Re: Cal883229BN-North & BS-South Nutrient Reduction Wetland (Bid 26-2)

Subject: **Addendum No. 1** to Bid Documents
CAL883229BN & CAL883229BS Nutrient Reduction Wetland Project – Bid No. 26-2
Calhoun County, Iowa

Plans (See Attachment No. 2): See revised set of Plans dated 04-28-2026

PROJECT
QUANTITIES

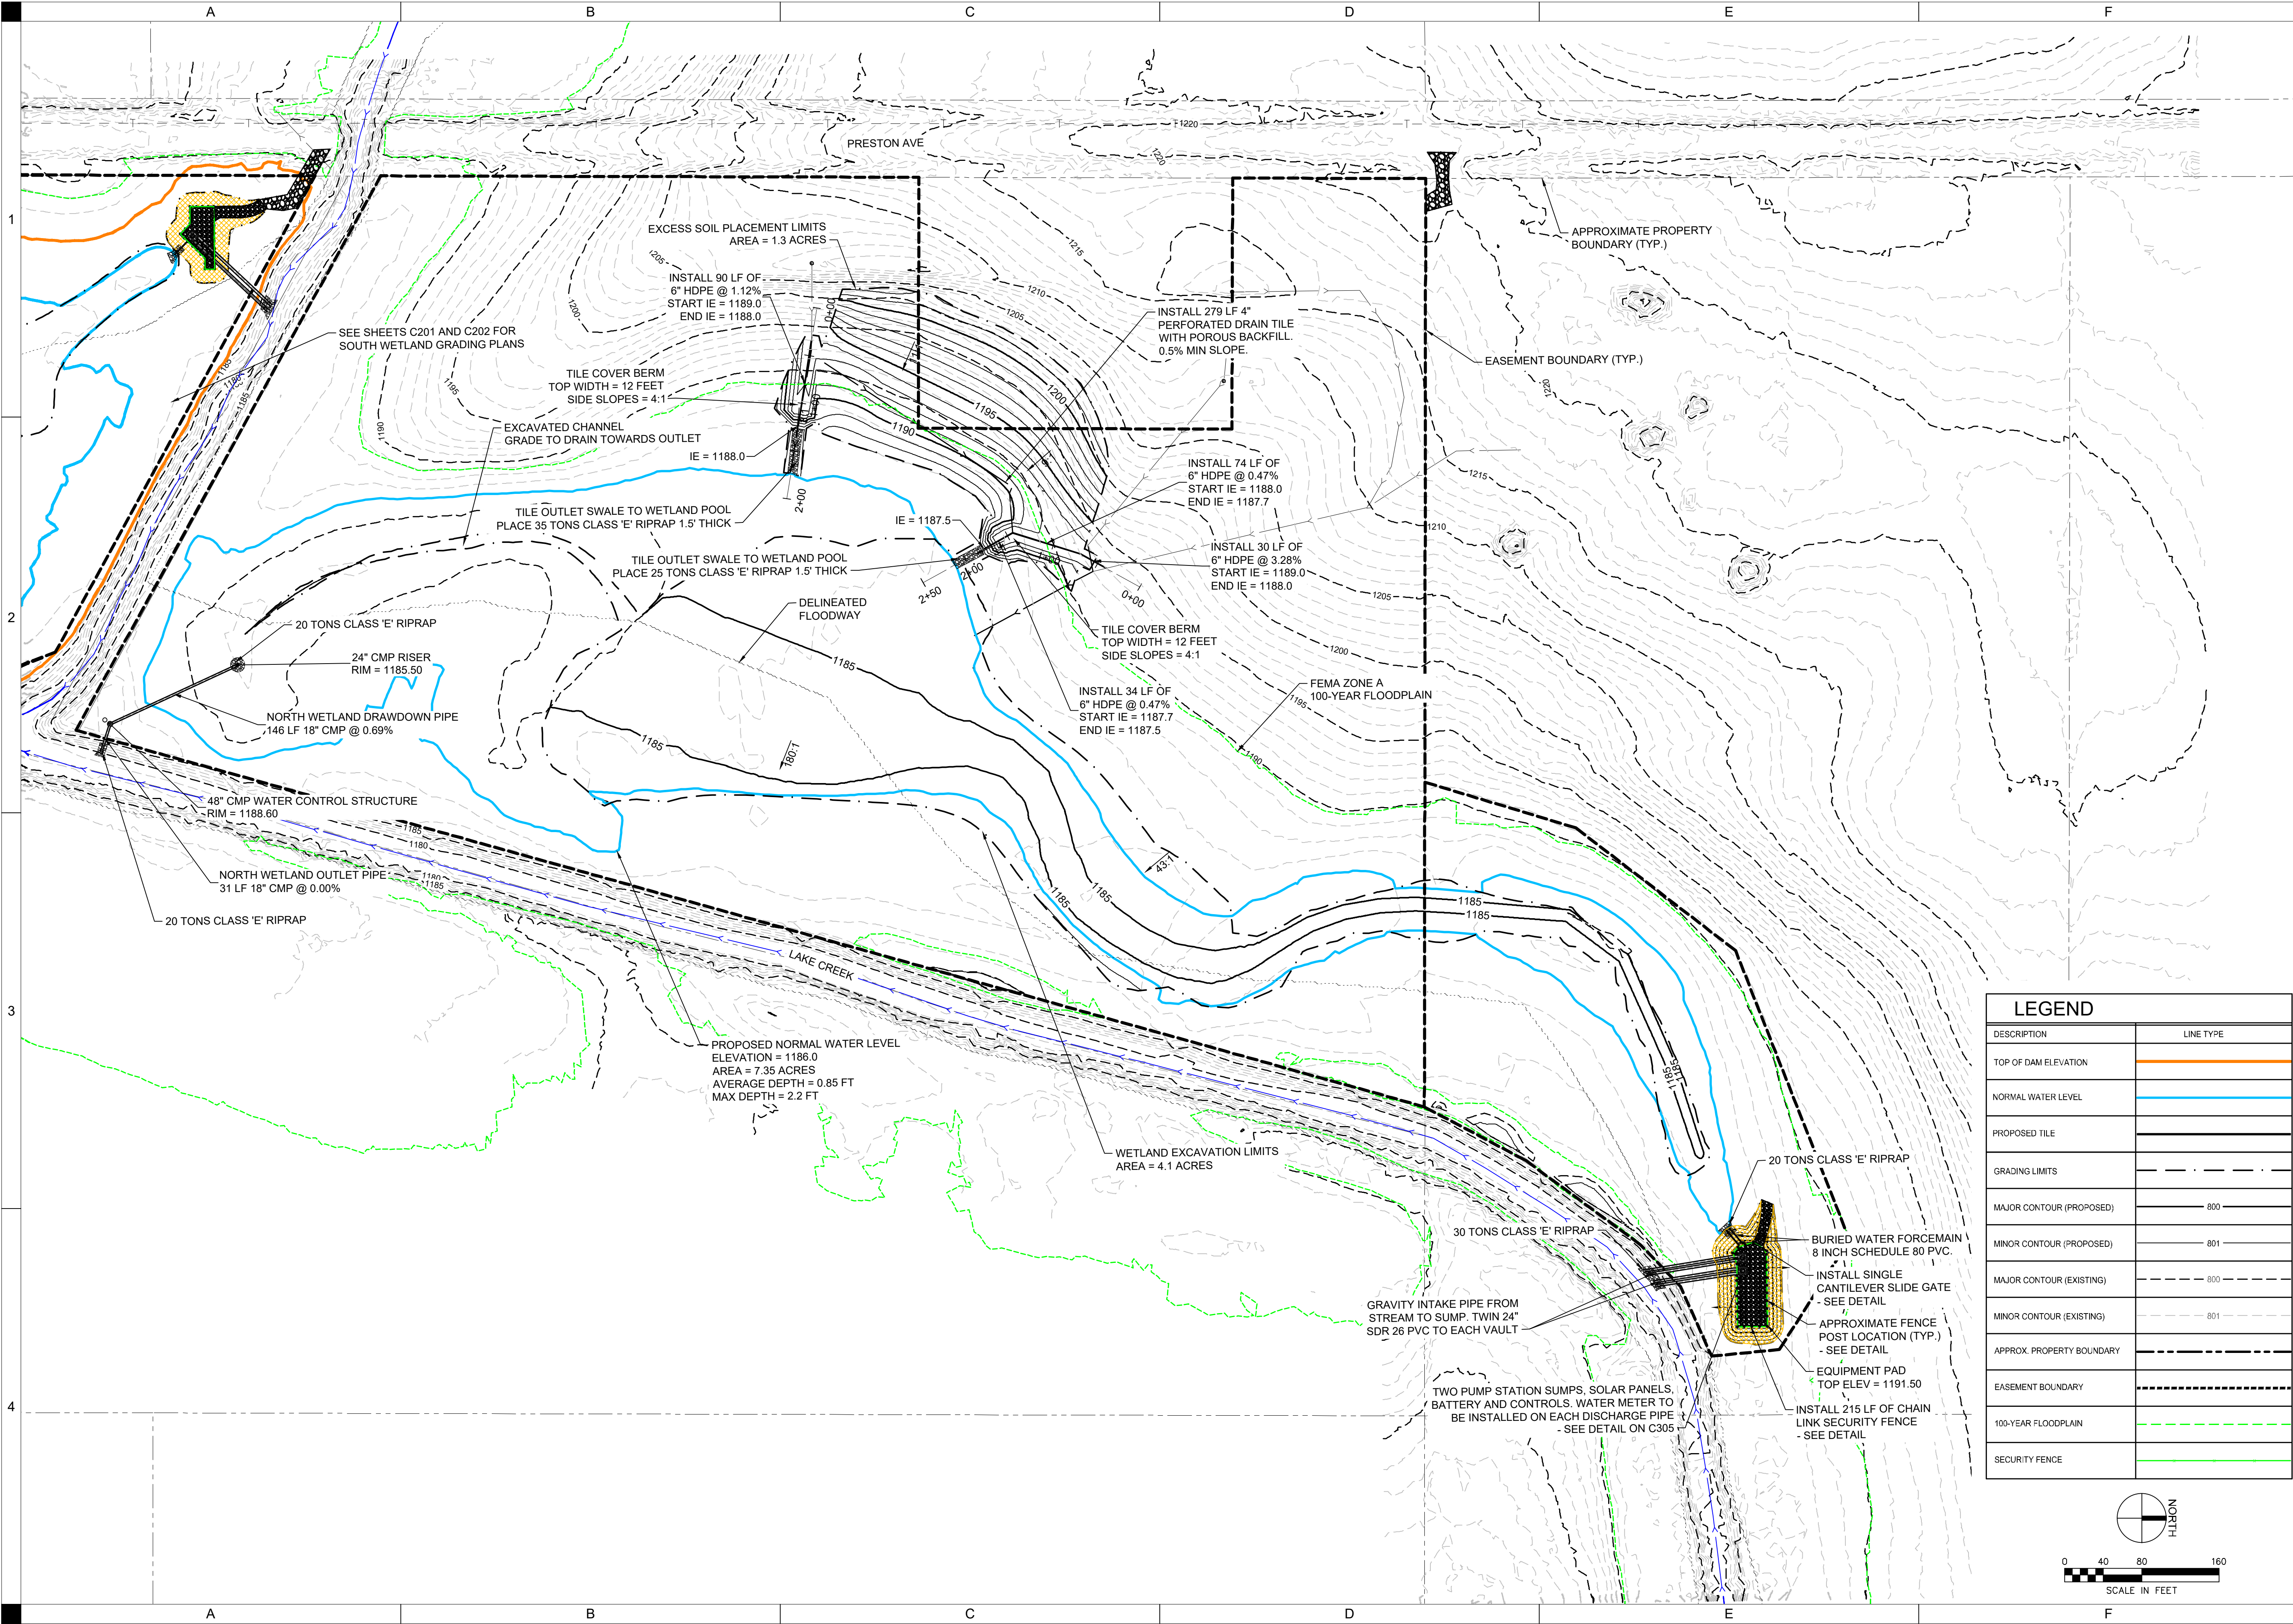
- Plans are noting the Drainage District that each wetland would be constructed at.
- The project quantities have been updated to include a single cantilever slide gate for each site.
- Bid items for chain link fence have been added to each of the lift stations.
- See revised set of Plans dated 04-28-2026.

CONSTRUCTION
DETAILS

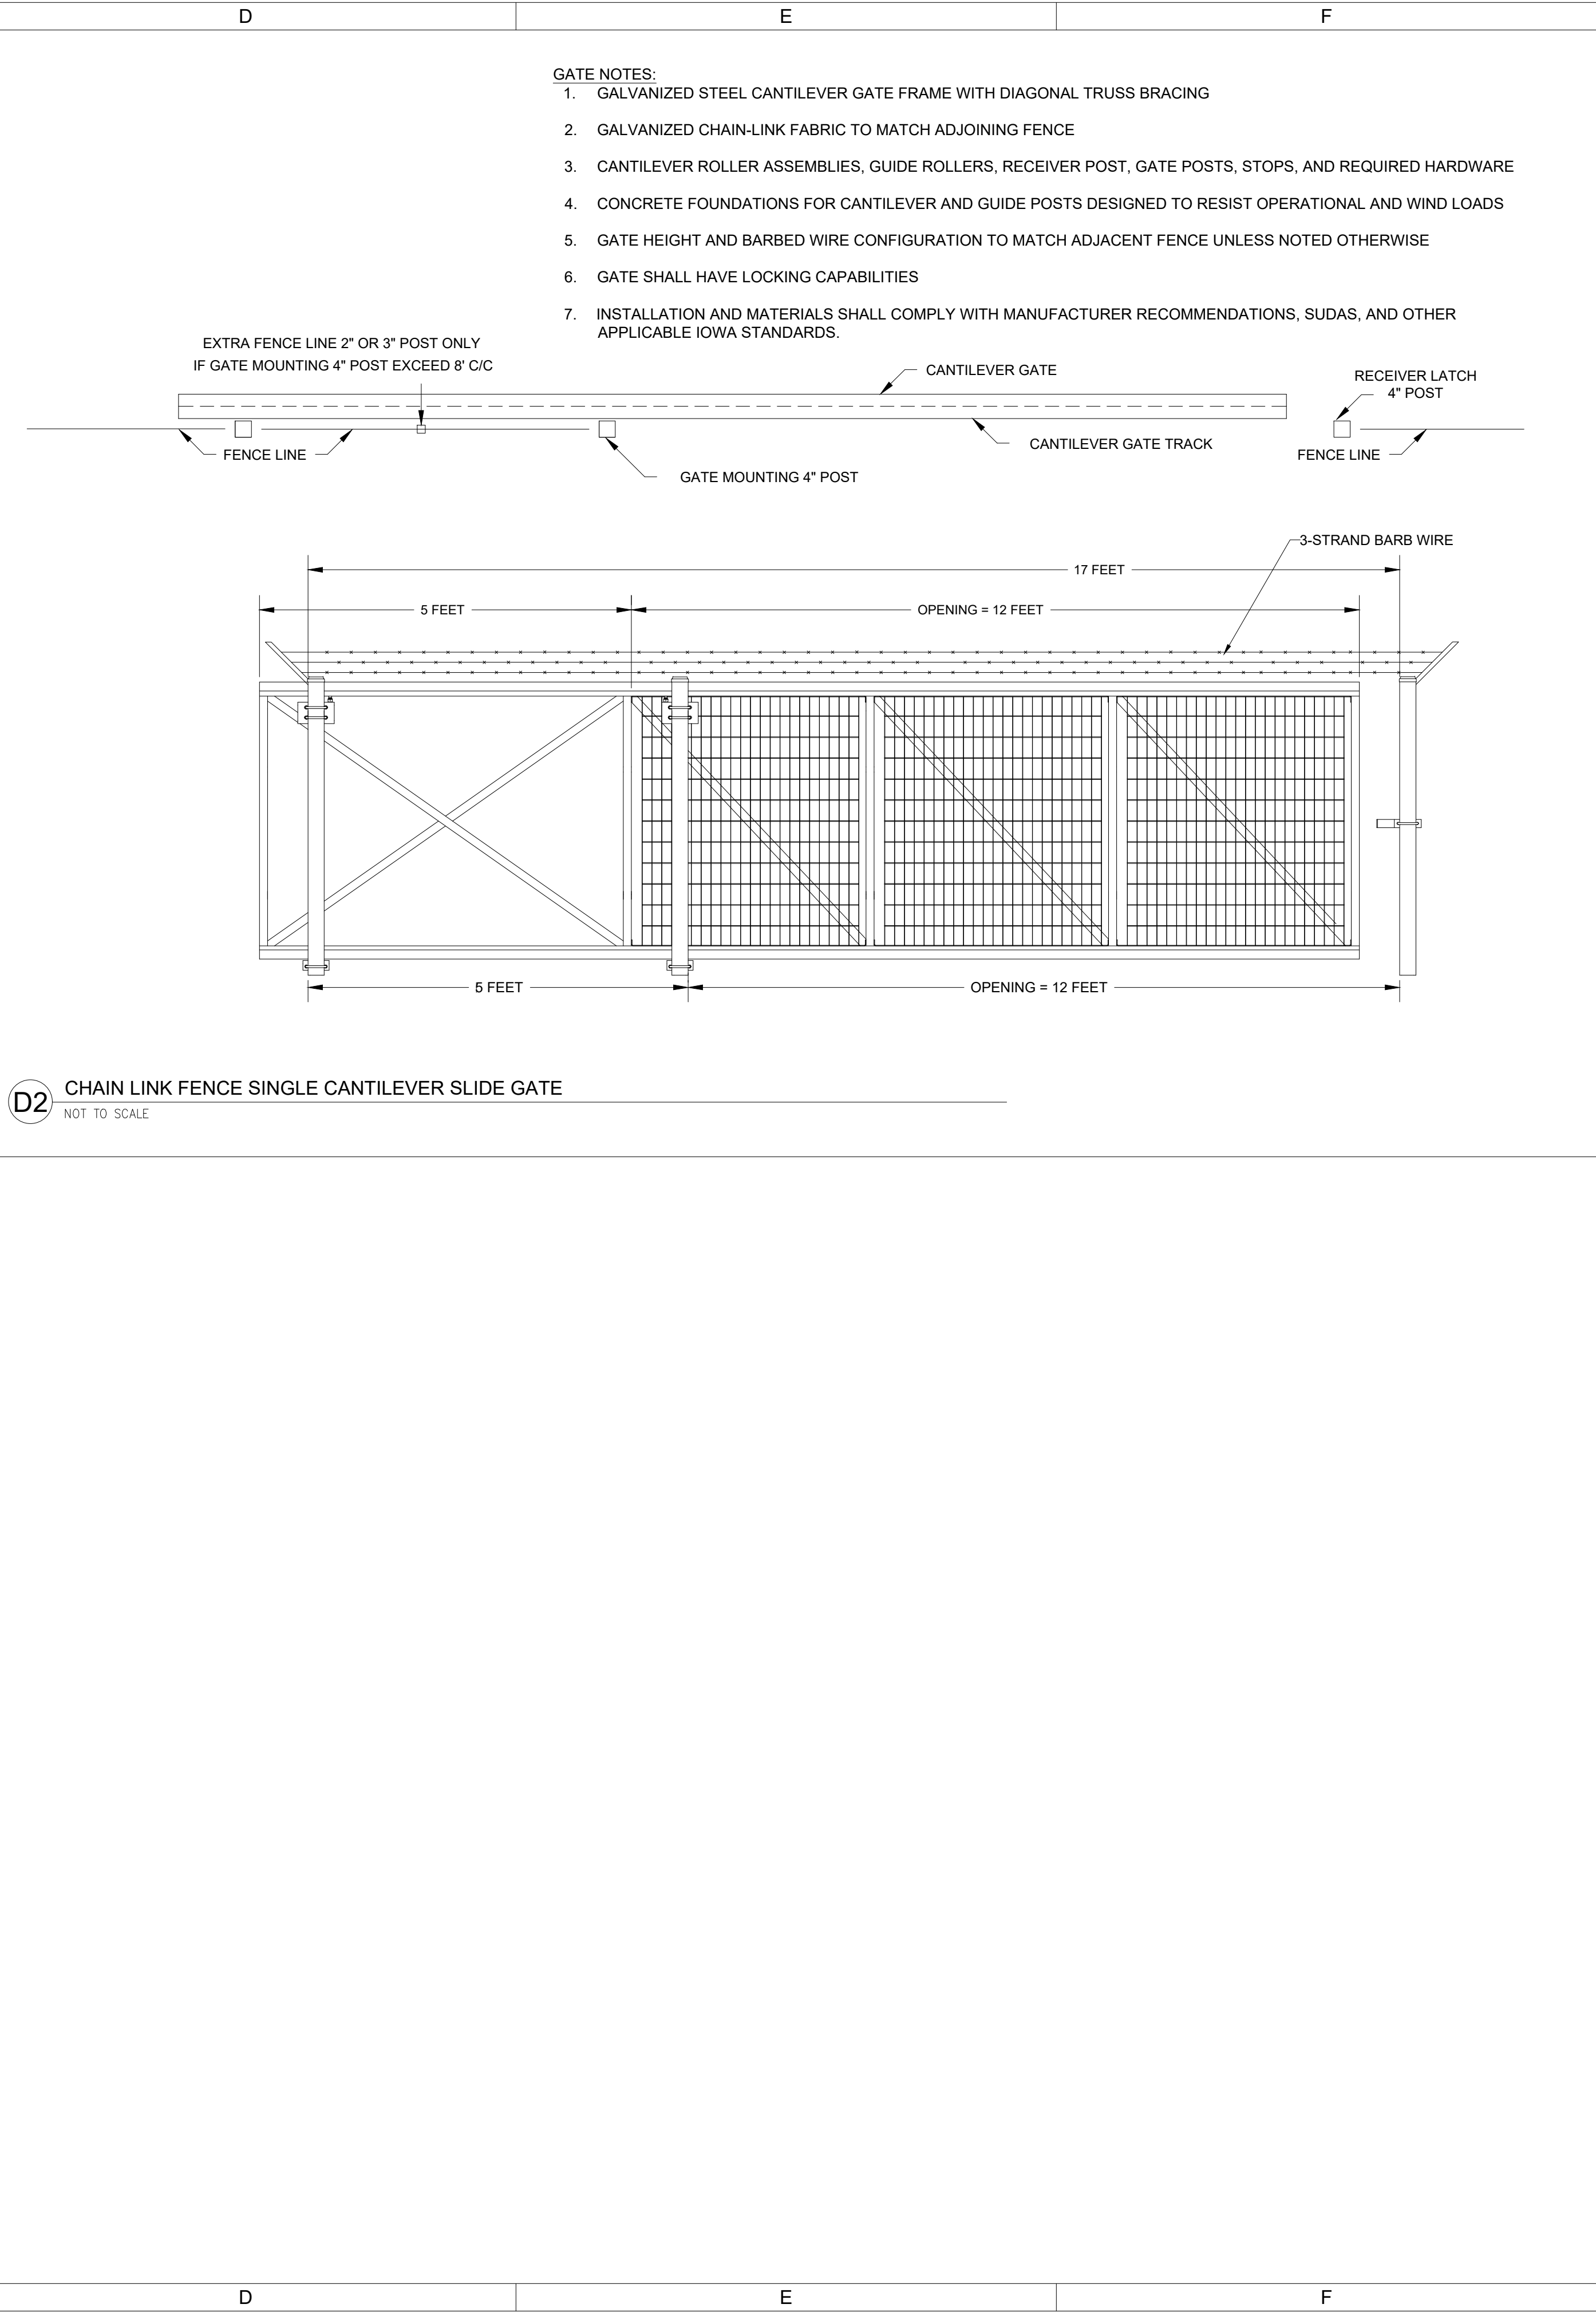
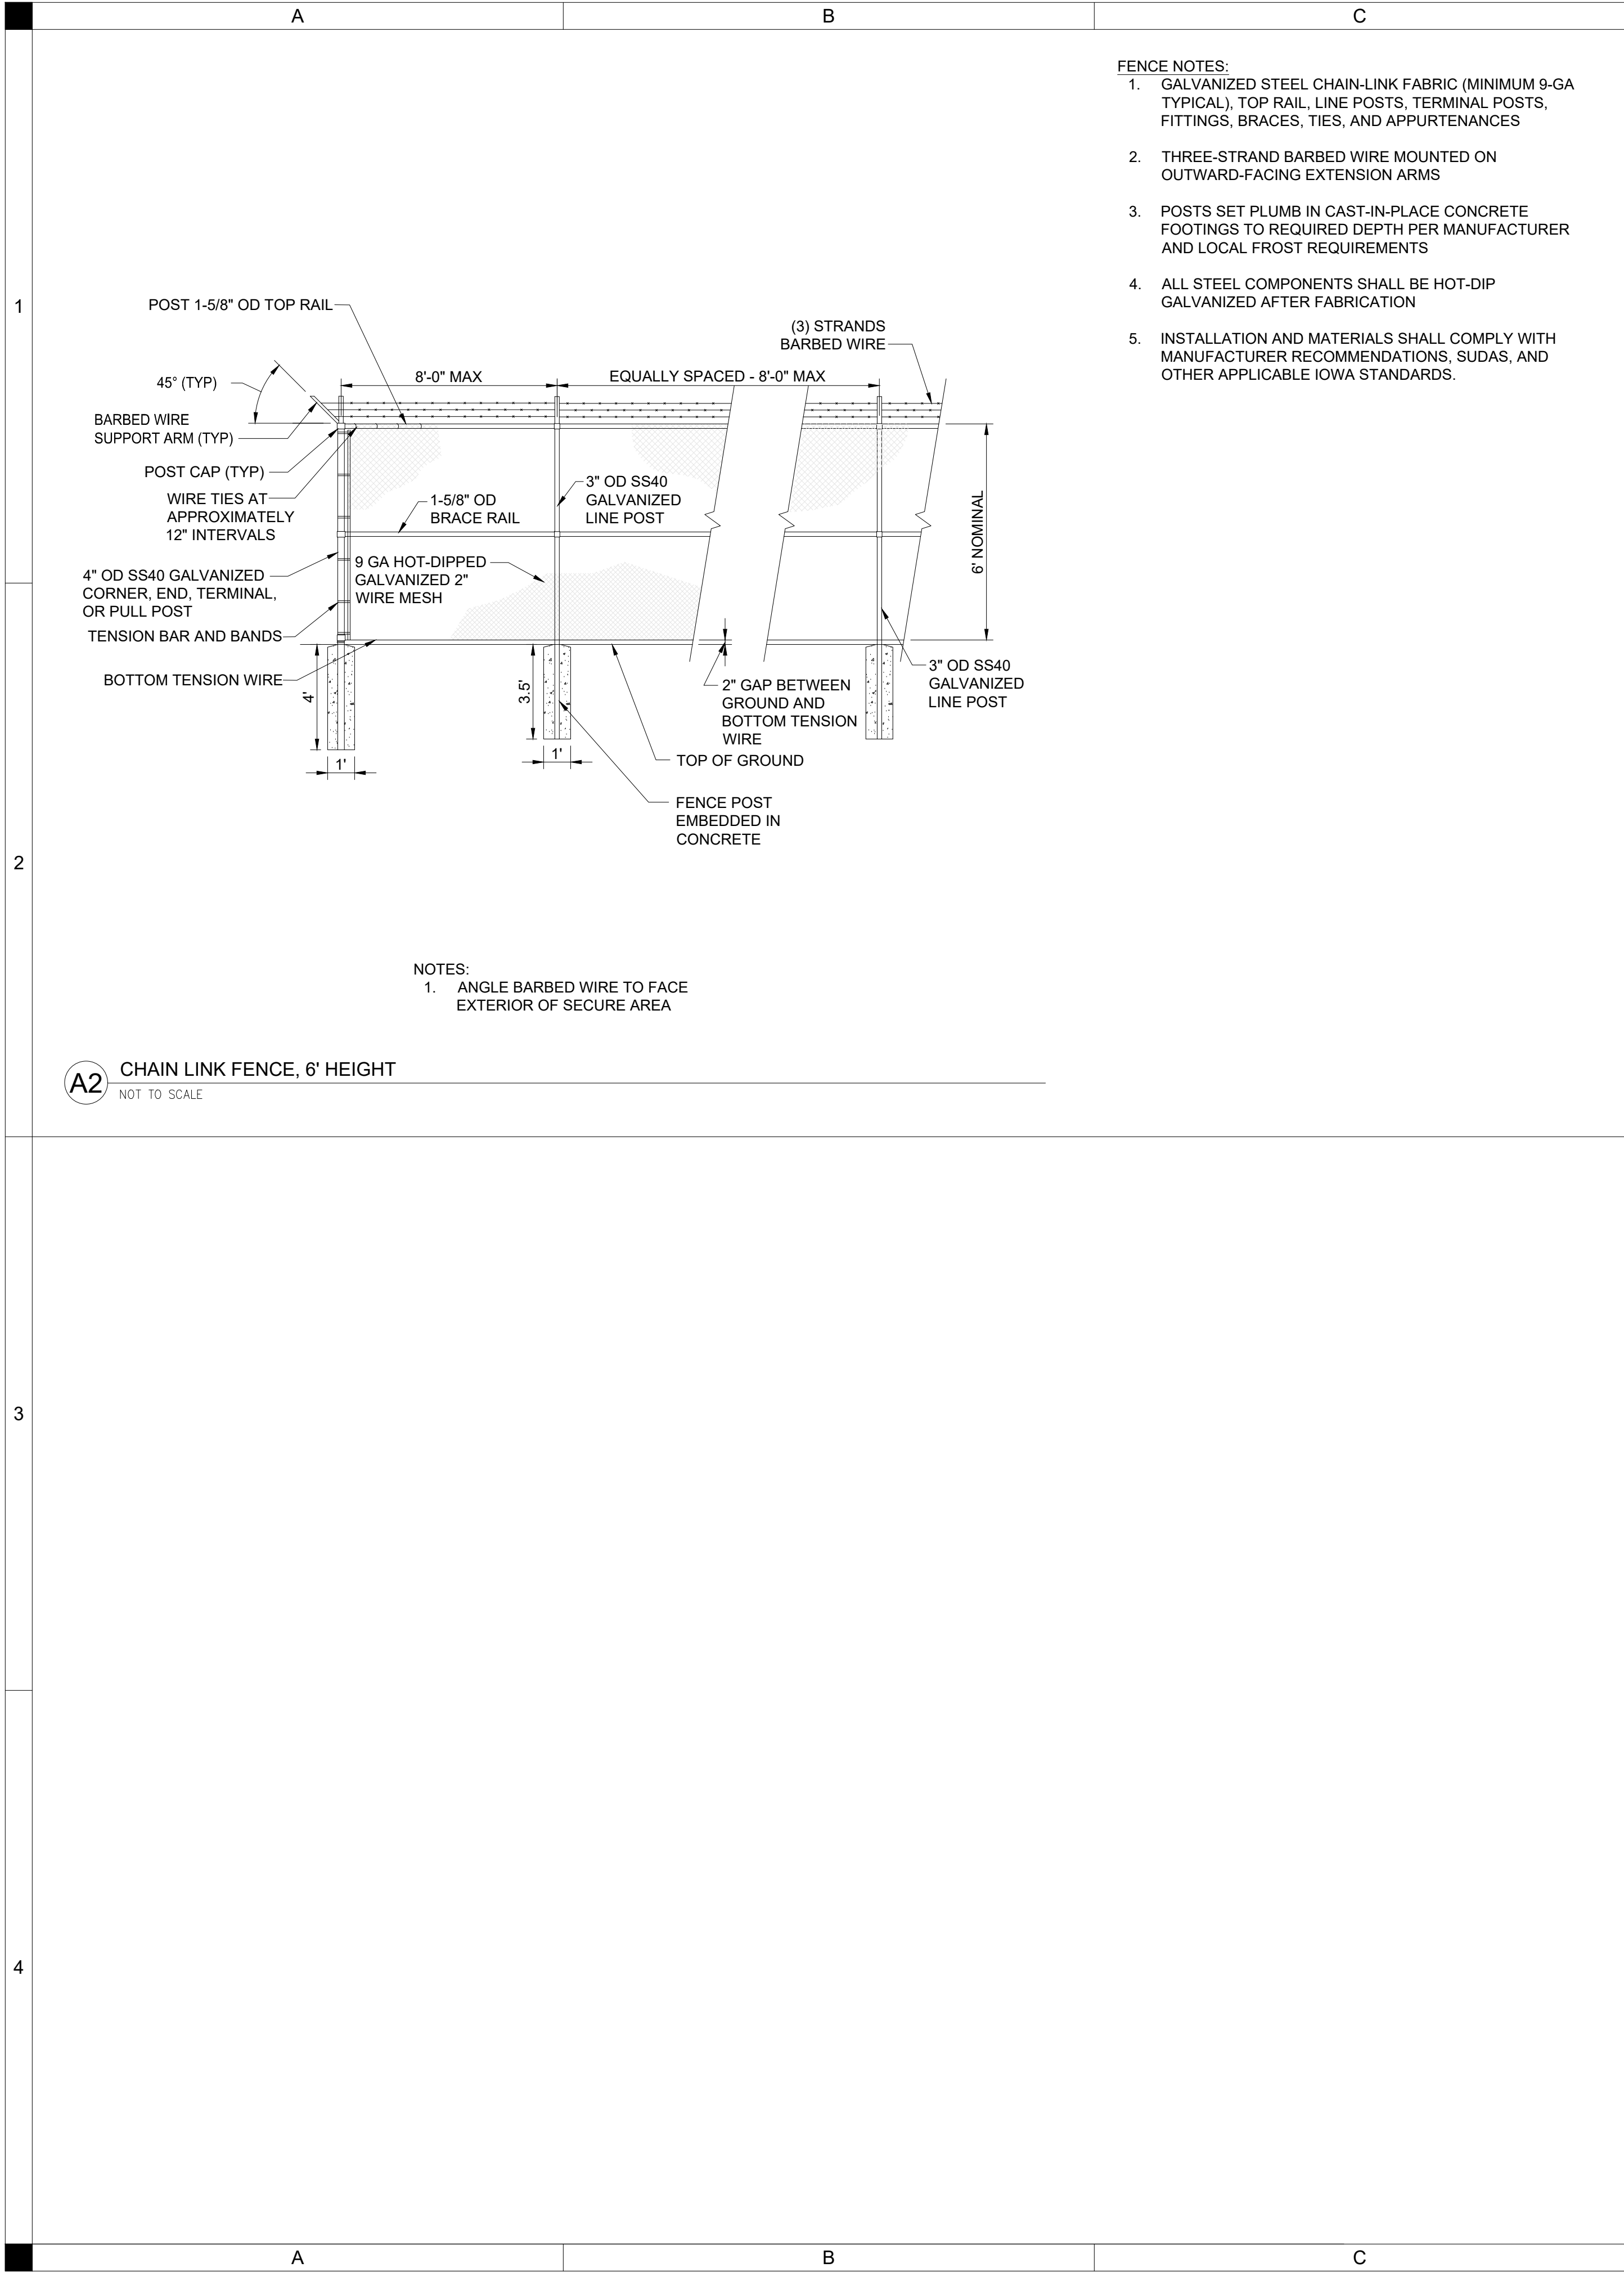
7. Addendum #1 has been issued to include the Drainage District Number that each of the projects are located at; and a chain link fence has been added to both lift stations (CAL883229BN & CAL883229BS). Bidders must acknowledge Addendum #1 or they would be disqualified.
